ADDENDUM NO. 2

HCEB Continuing Education Office Remodel Floors 1 & 4

Brigham Young University  
Planning & Construction Dept.  
240 Brewster Physical Plant  
Provo, Utah 84602  
26 February 2024

**BRIGHAM YOUNG UNIVERSITY  
CONTINUING EDUCATION OFFICE REMODEL LEVELS 1&4  
Work Order No. N1864-N3482**

**N3482  
A1.0**

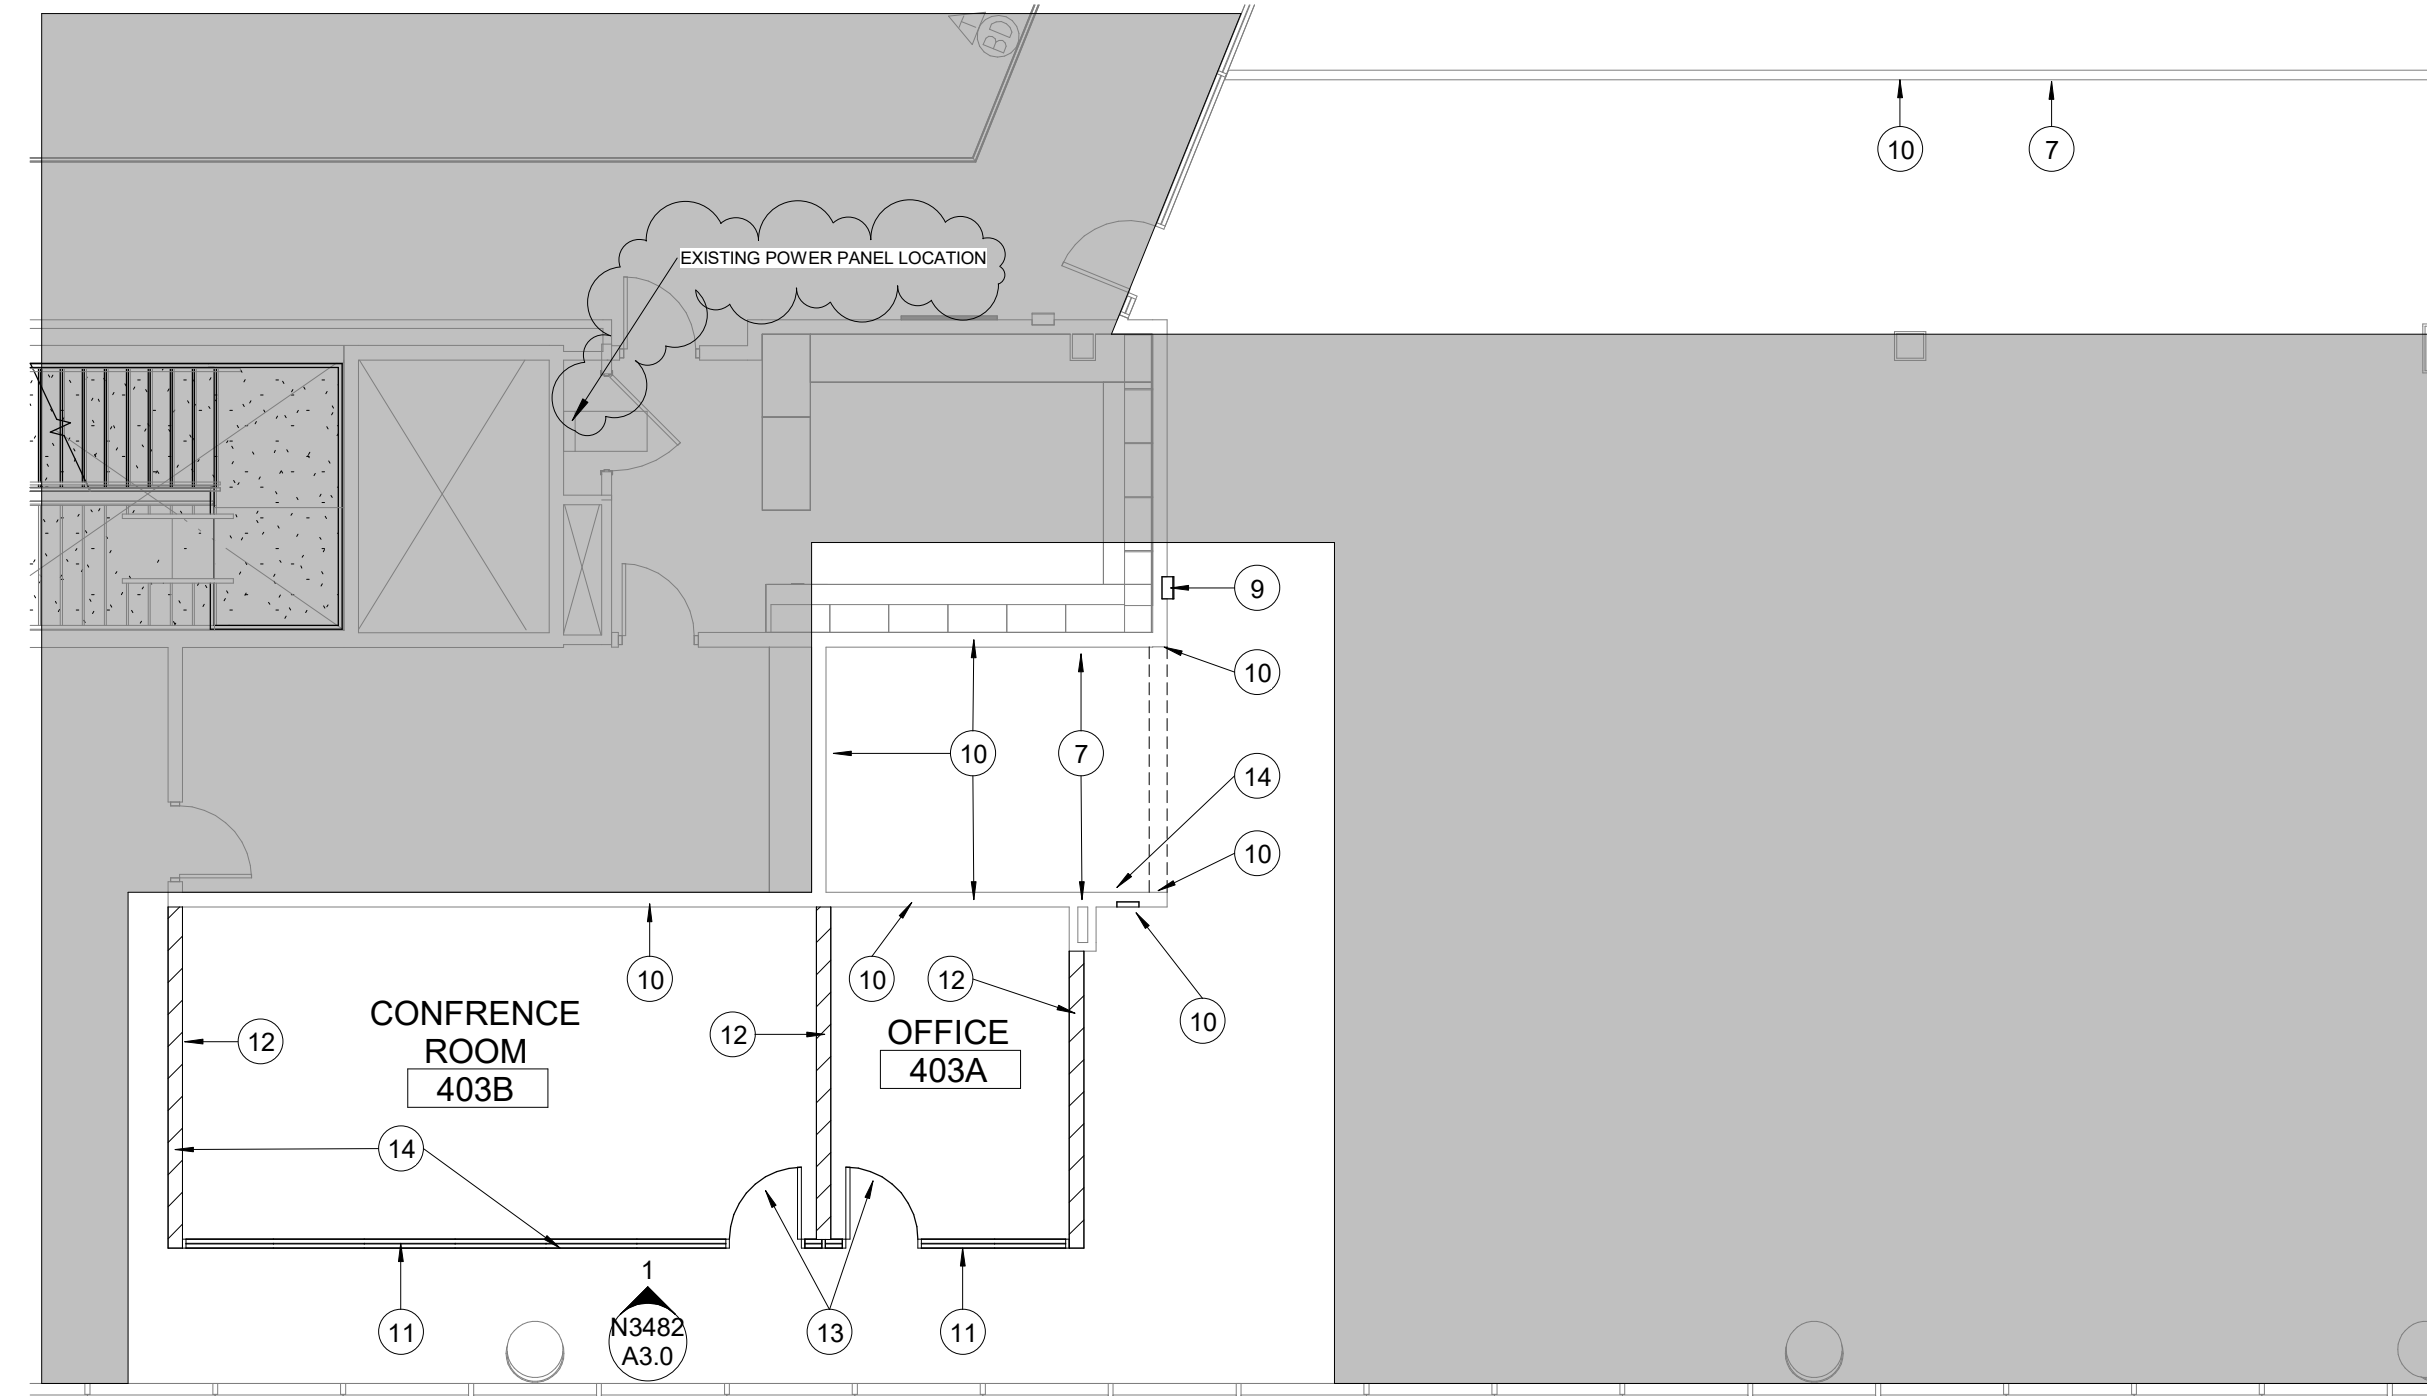
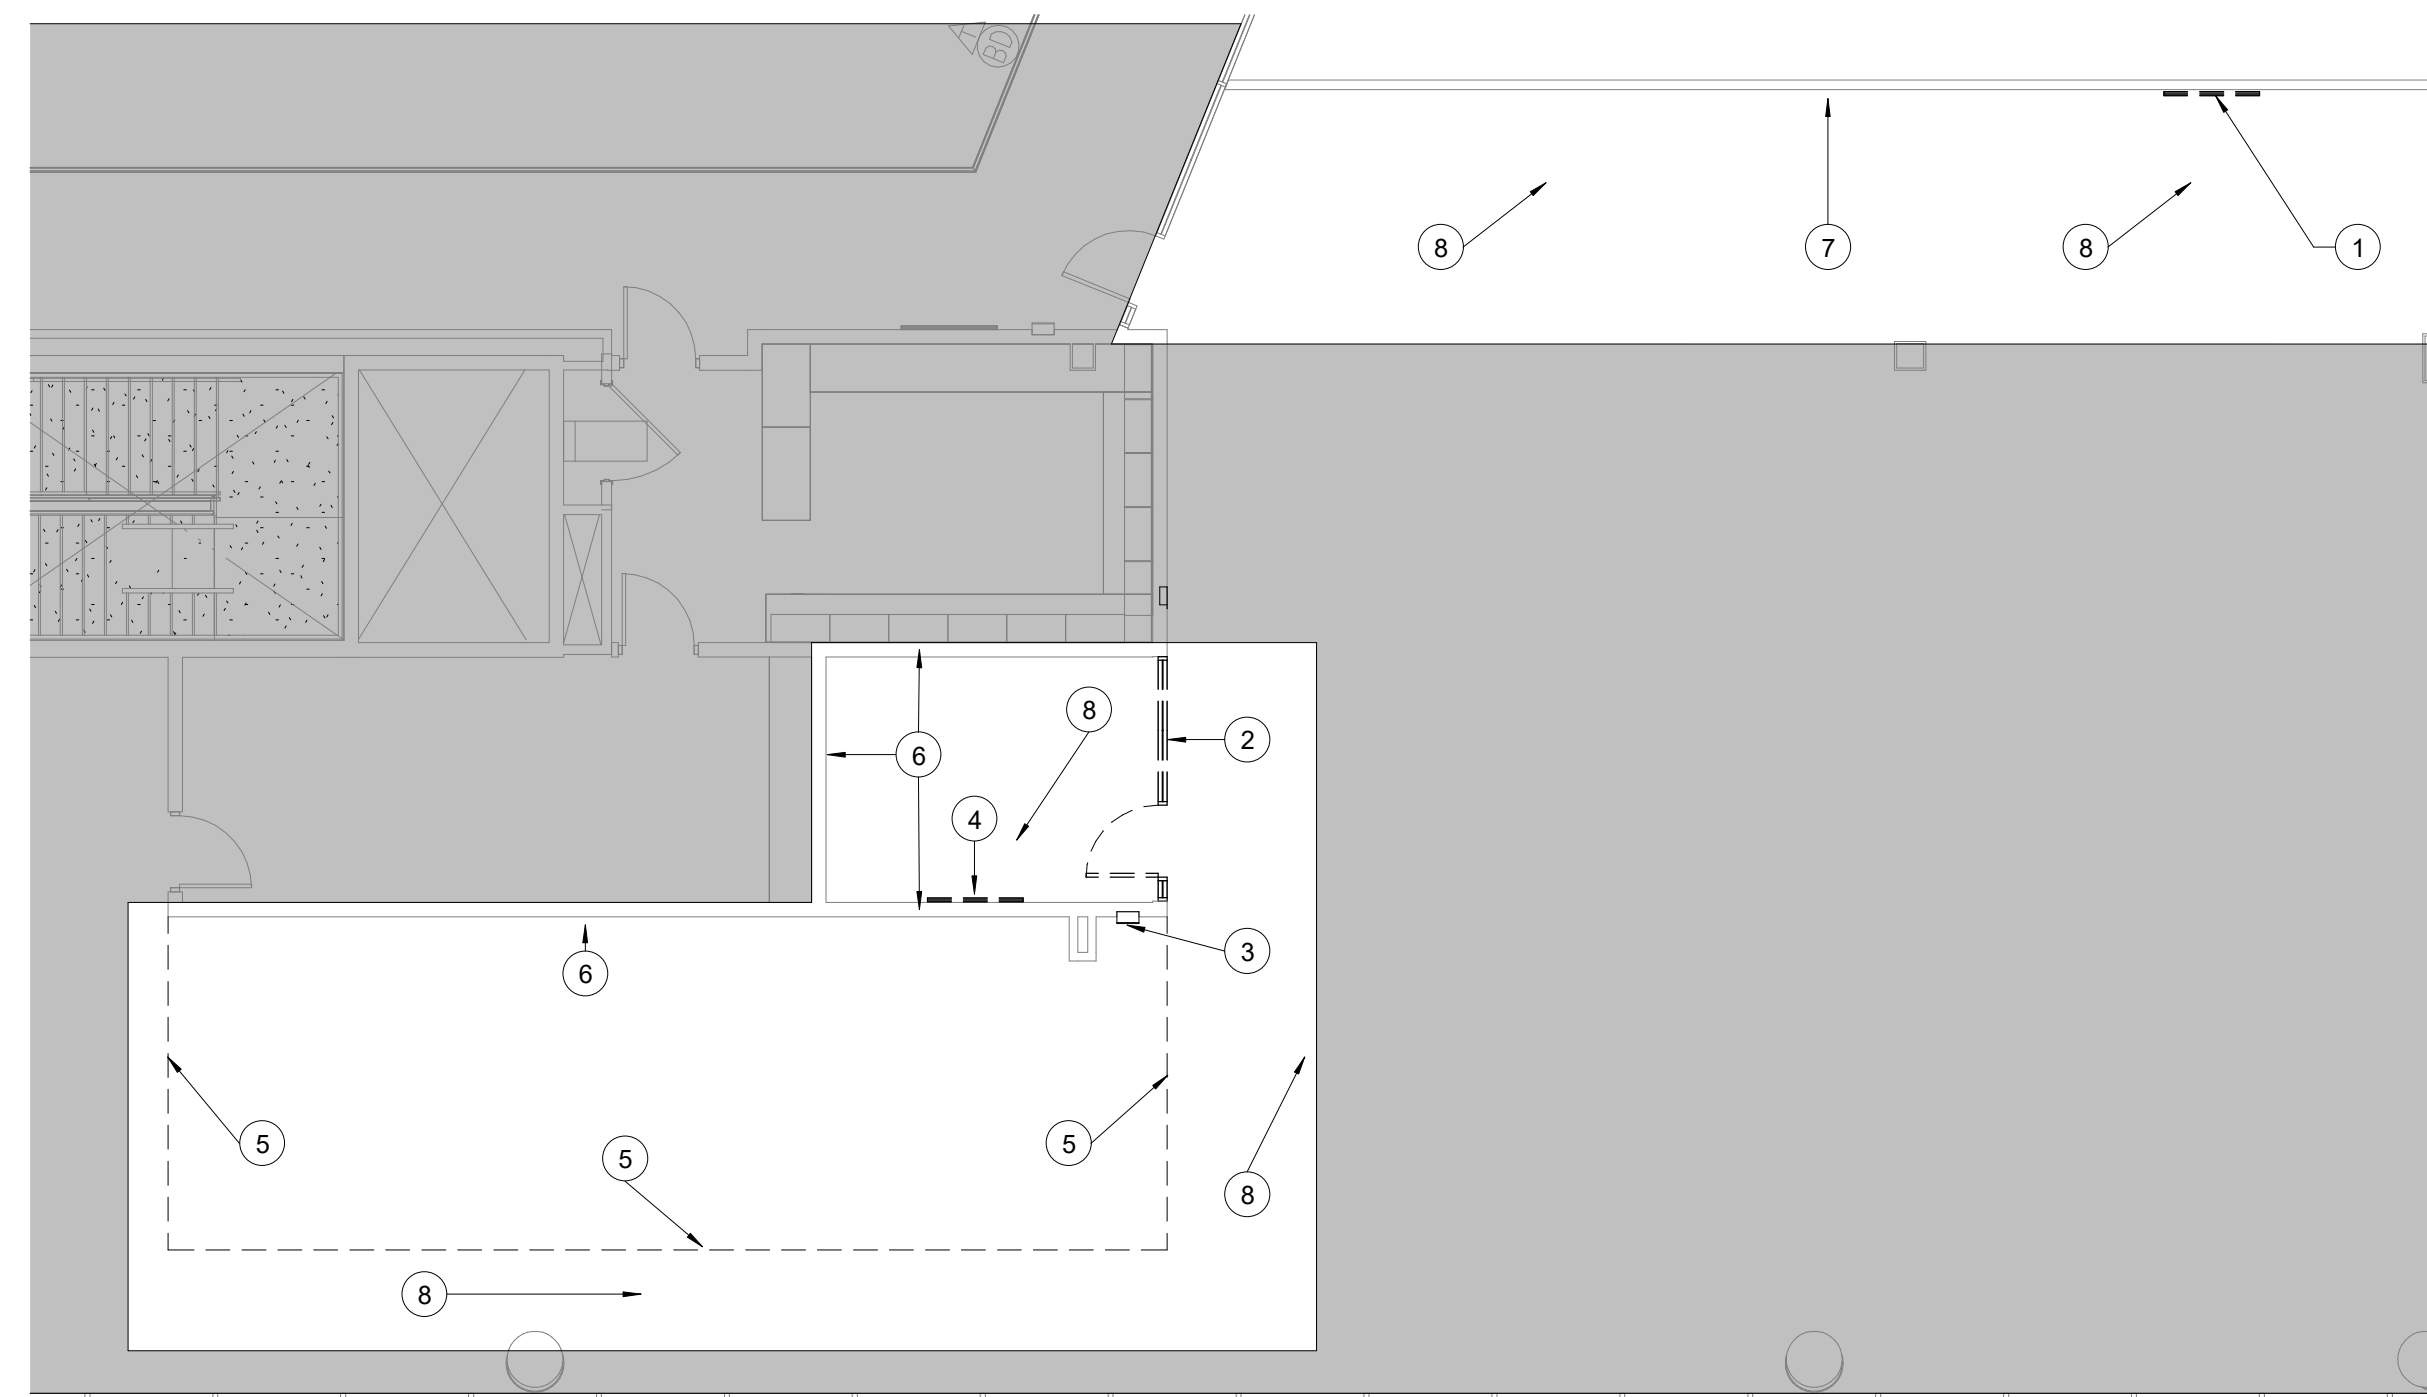
1. Sheet A2.0 N1864 (Level 1) See added notes for finished ceiling heights.
2. Sheet A4.0 N1864 (Level 1) See update sheet for hardware group 1 & 2.
3. Sheet A1.0 N3464 (Level 4) See added note for electrical panel location.
4. Sheet A1.0 N3482 (Level 4) note 7 refers to any modifications to the electrical and low voltage pathways noted on already issued electrical sheet. Use electrical sheets as the guide.
5. Sheet A2.0 N3482 (Level 4) See added notes for finished ceiling heights.
6. Sheet A3.0 N3482 (Level 4) Added Keynotes reference.
7. Sheet A4.0 N3482 (Level 4) See update sheet for hardware group 2.
8. Location of Electrical Panel Room notated on Sheet E1.0
9. USG Frost 490 is the only acceptable ceiling tile on this project.
10. There are no ACT-1, ACT-2, ACT-3 panels in this project, disregard in specs.
